- 1.1 This addendum modifies the Bid Documents for the Jennie E. Hughes Park Improvements project.
- 1.2 This Addendum forms a part of the Bidding Documents and will be incorporated into the Contract documents, as applicable.
- 1.3 Acknowledge receipt of all addenda prior to submittal of bid, by reference in the bid form.

JENNIE E. HUGHES PARK IMPROVEMENTS
6448 Sewanee Ave.,
West University Place, TX 77005

NO.	DATE:	DESCRIPTION:
	3/6/2018	100% Construction Drawings
	4/11/2018	Addendum #1

L6.04

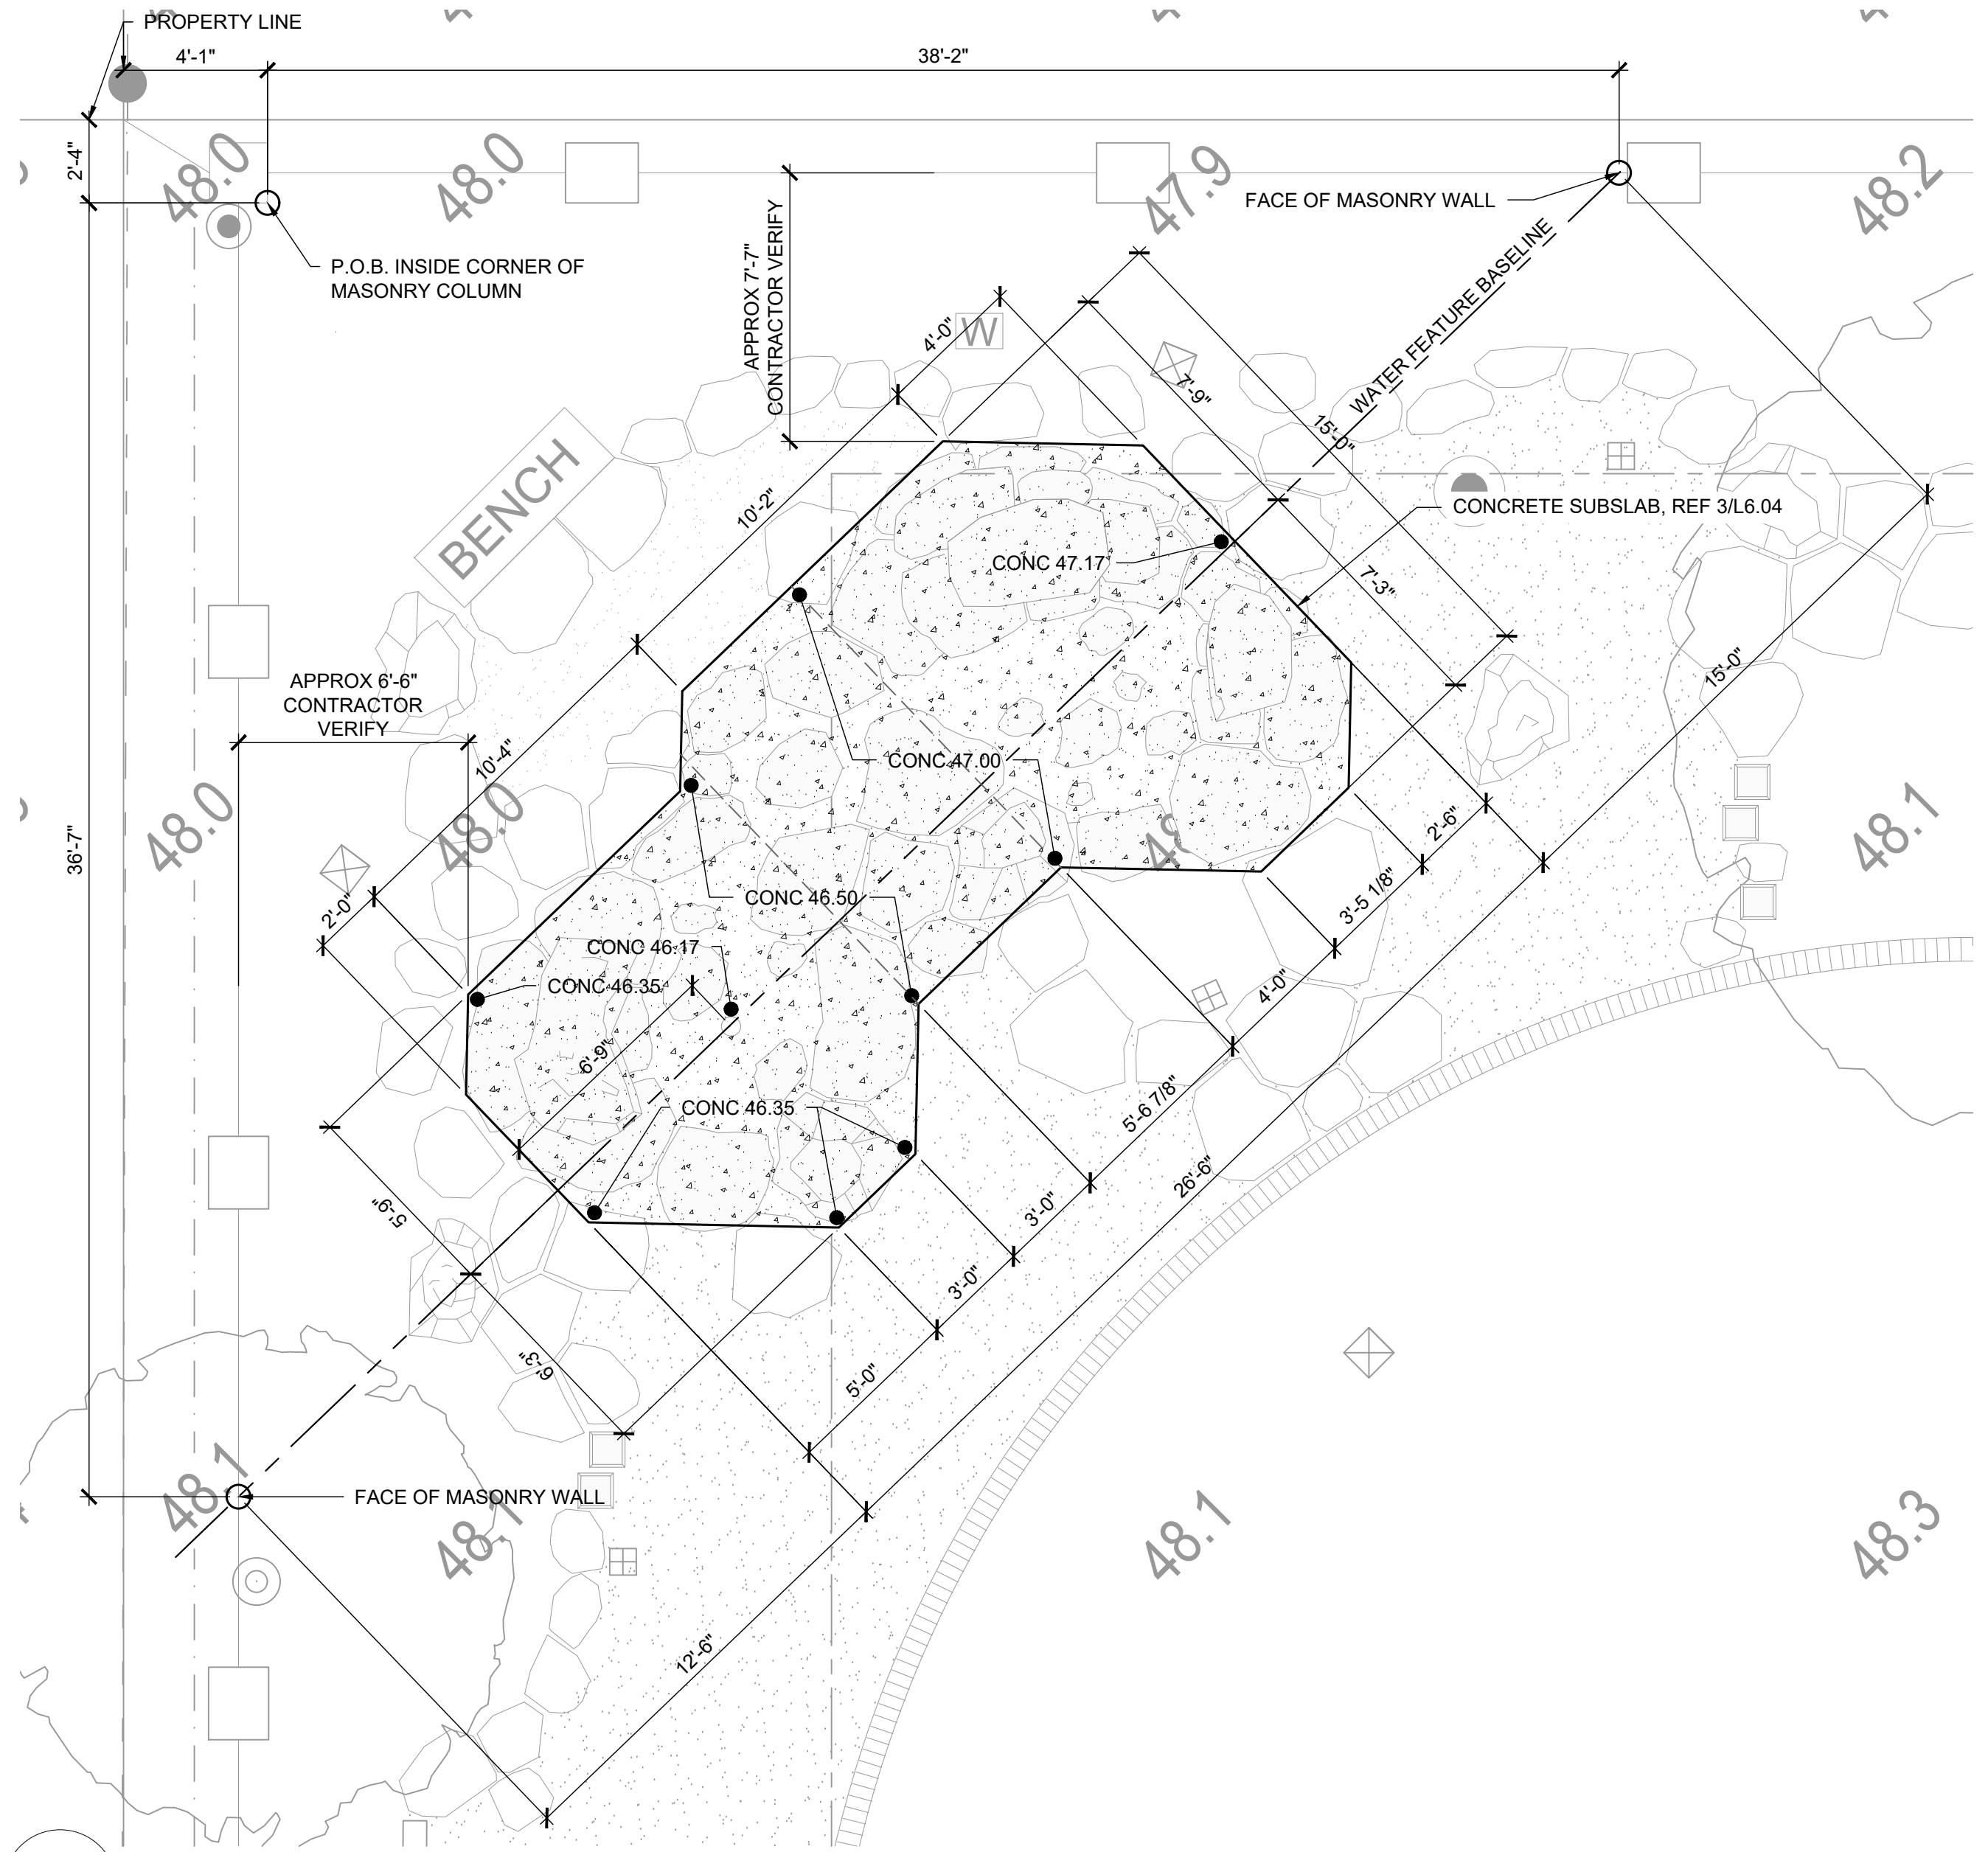
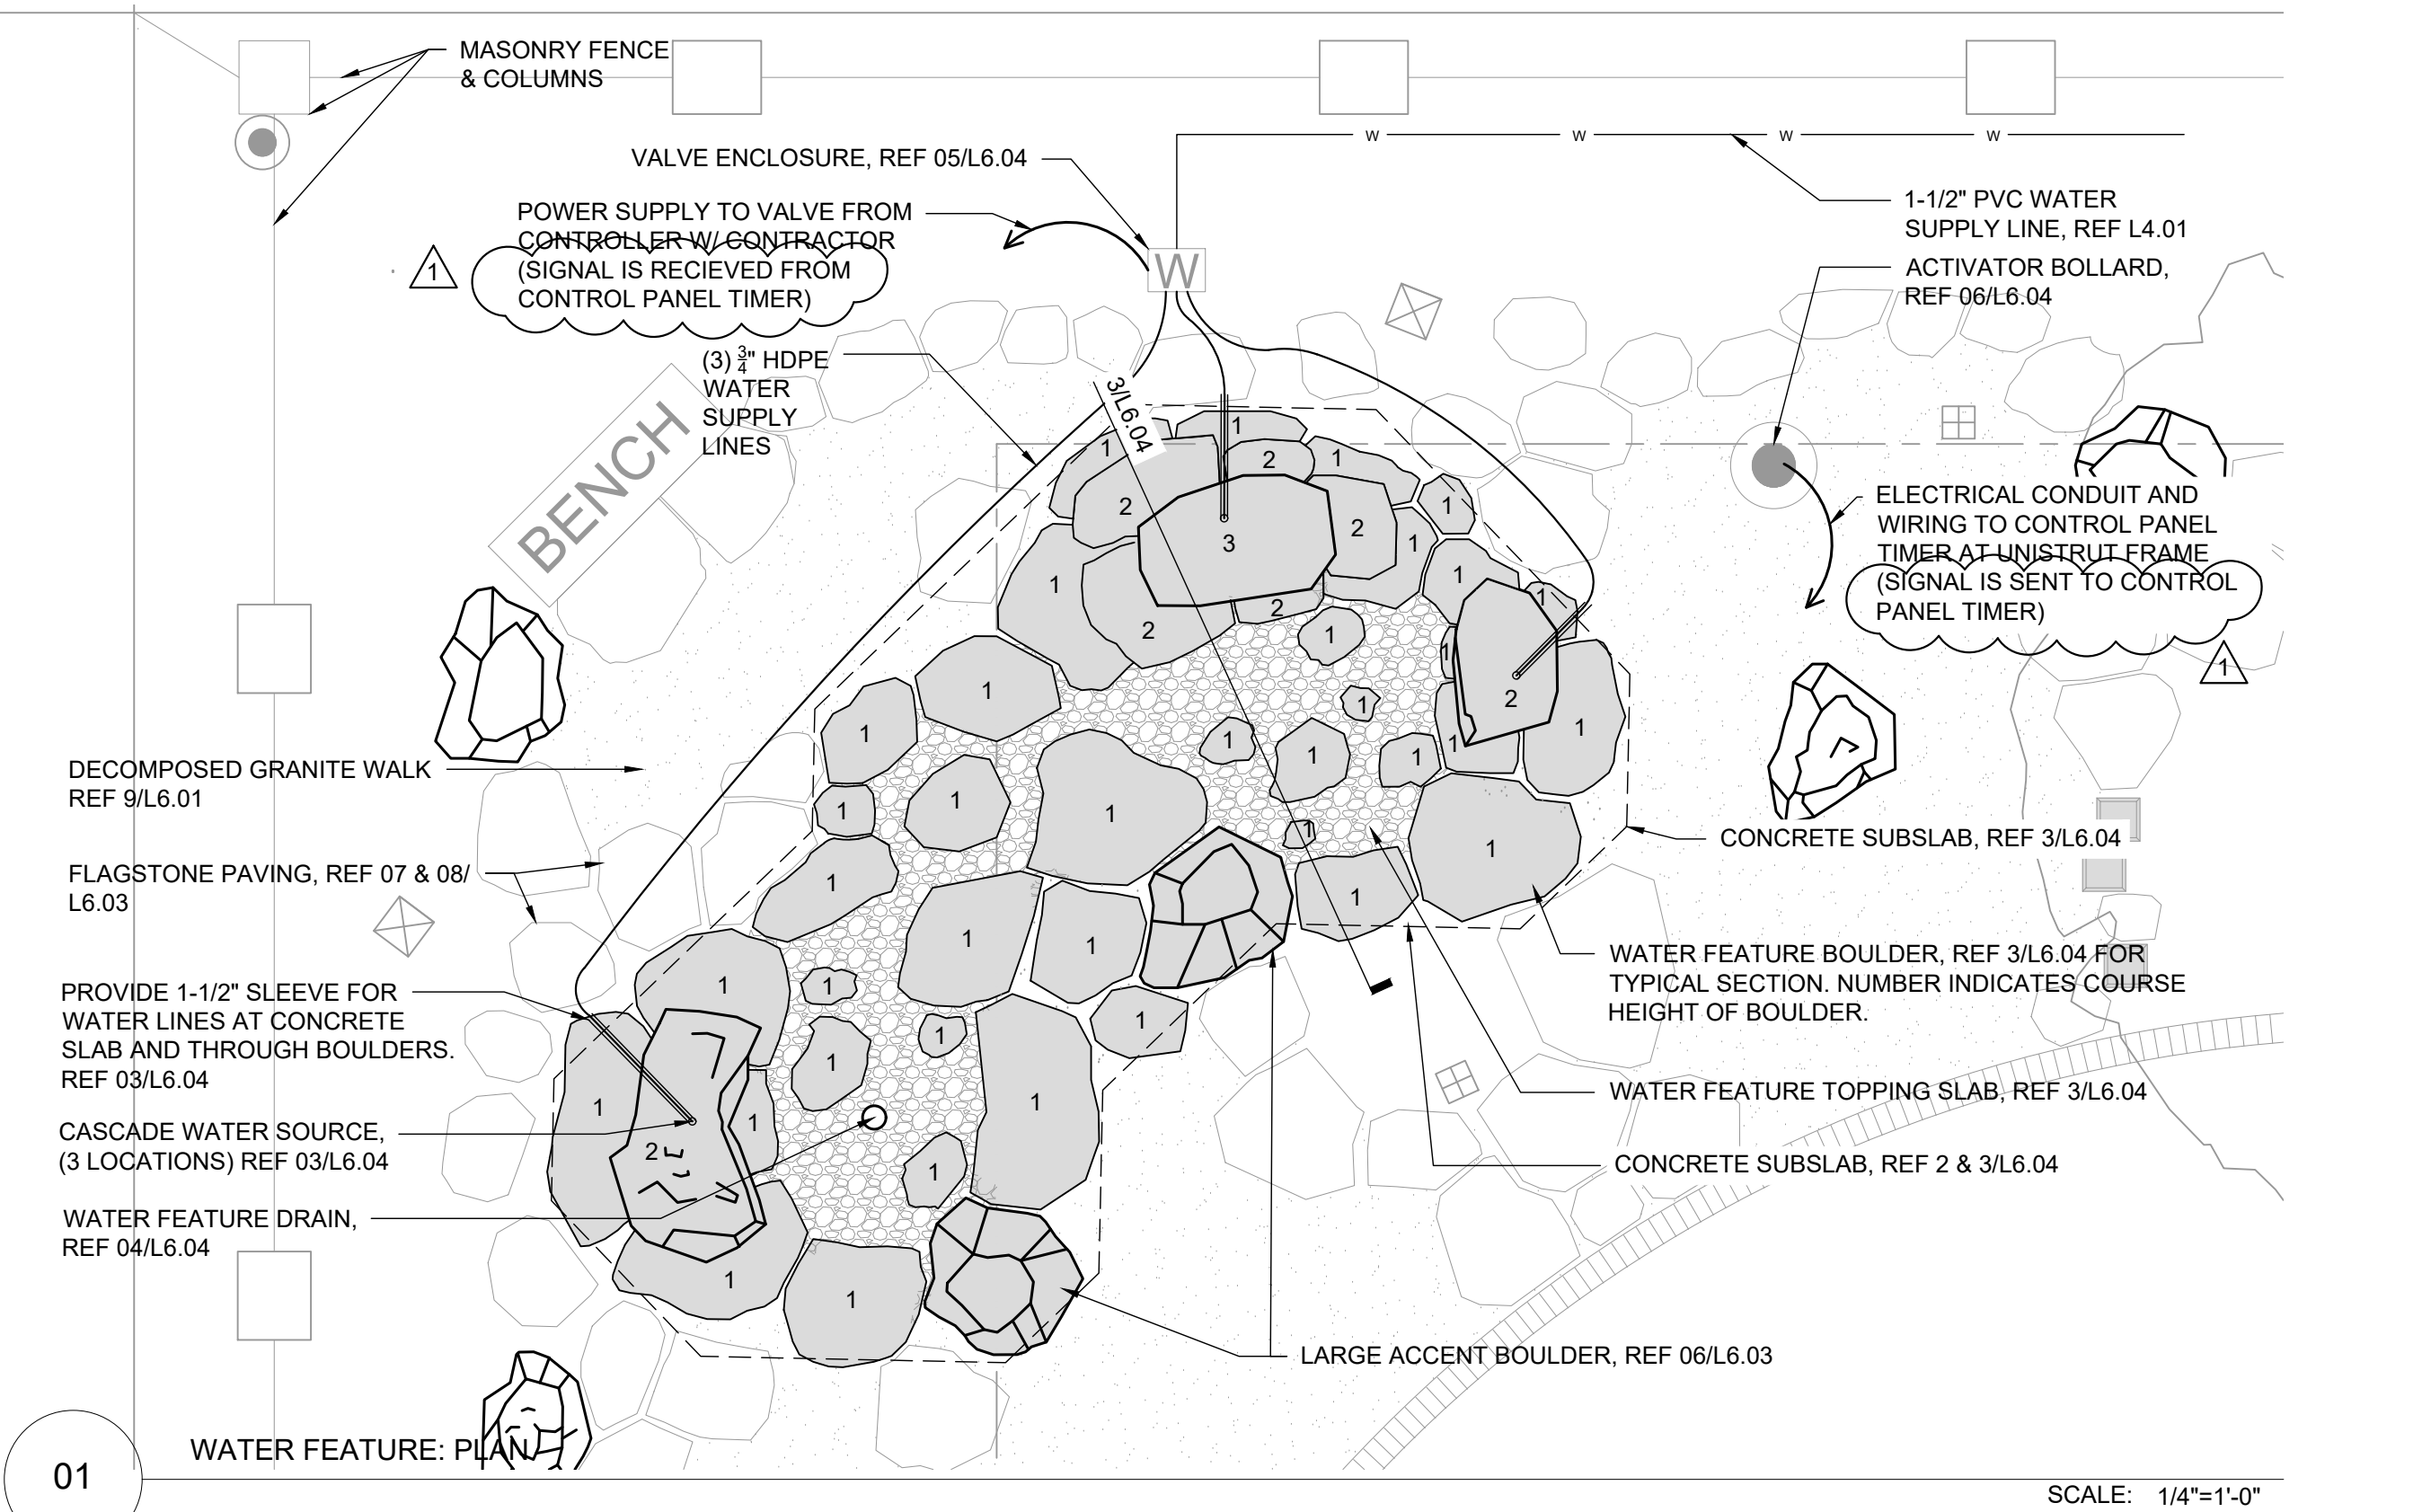
- 3.1 L0.01 - Demolition of concrete unit retaining wall added to scope.
- 3.2 L3.01 – Description of grading work between sidewalk and street curb at previous retaining wall locations provided.
- 3.3 L6.04 – Raindrop representative added to notes. Revised activator bollard model number. Control Panel Timer model number provided. Description of conduit routing provided within detail 01.
- 3.4 L6.23 – Detail path callout revised.
- 3.5 LE1.01 – Service size revised. Additional notes provided. Description of conduit routing provided for activator bollard and water feature valve.

1. Products & Finishes
 - 1.1. Raindrop Products - Contact Steven Bearden 951.310.1491 - sbearden@rain-drop.com.
 - 1.1.1. Activator Bollard - (BOL-005) by Raindrop Products. Submit standard colors for selection.

- 1.1.2. Control Panel Timer - (TMR-008) by Raindrop Products.
 - 1.2. Valve Box - Carson T324, Black lid w/ Drop-N-Lock option.
 - 1.3. Valve - 1-1/2" Brass remote control valve, Rainbird EFB-CP.
